PZ&B Staff Combination Memo: Town Council Development Review and Architectural Commission

SUBJECT: ZON-23-079 (ARC-23-110) 2773 S OCEAN BLVD (COMBO)

MEETING: AUGUST 09, 2023 TC
AUGUST 23, 2023 ARCOM

The applicant has submitted plans, entitled "Landscape & Parking Material Change 2773 South Ocean Boulevard", as prepared by **BGS Landscape Architecture & Engineering**, dated July 11, 2023.

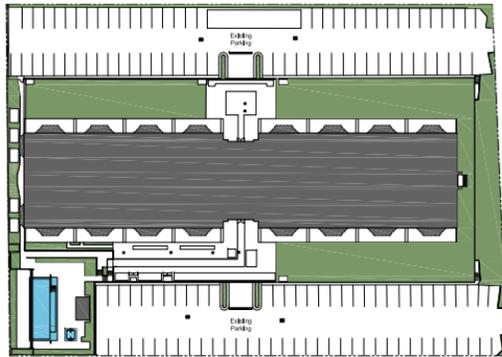
VARIANCE 1, the applicant is proposing to install two new entry canopies along the north and south sides of the site to provide shelter from the parking areas towards the main building entrances. Each canopy is measured at 31' in width and 15' in depth and are flanked by two planters. The 450 SF (each) of the existing entrance canopies count towards the overall lot coverage of the site, which is currently nonconforming. The canopies have a clearance height of 7'-6". They are proposed to be in Sunbrella 'Sea Mark Oyster' fabric; the structural frame and vertical support posts are in 4" members that are powder-coated white.

PROPOSED LANDSCAPE OPEN SPACE DIAGRAM
(Phase 2)

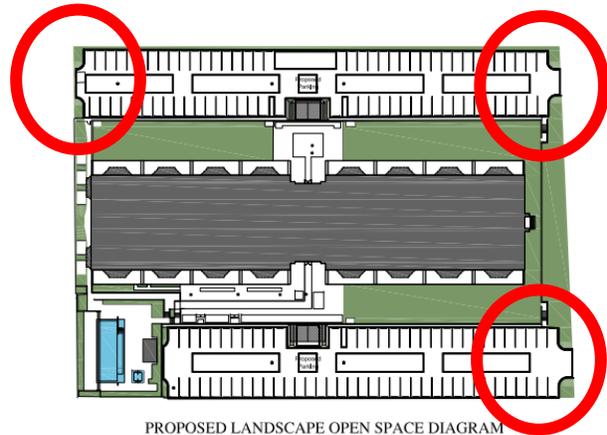
VARIANCE 2, the applicant is demolishing the existing north and south parking areas, capturing additional parking, and installing new landscaping. With the combination of Phase 1, and this scope, the Carlyle house is removing nearly 100% of the 'open space' of the site which includes

the parking areas. PZB applies the nonconformance section of the Code to maintain the site to today's zoning requirements. For multifamily uses, the minimum landscaped open space is 35 percent. The applicant is proposing to retain an existing-nonconforming landscape open space of 21%, where 35% is required, and 20% is existing. The applicant is improving the amount of greenspace on the site by 1%, mostly at the three 'corners' (NW, NE, and SE) of the site along with the more efficient restriping that increased the number of parking spaces. In addition to the new landscaping, the parking area are proposed to be improved to pavers set in a herringbone pattern in grey hues in lieu of the existing asphalt field.
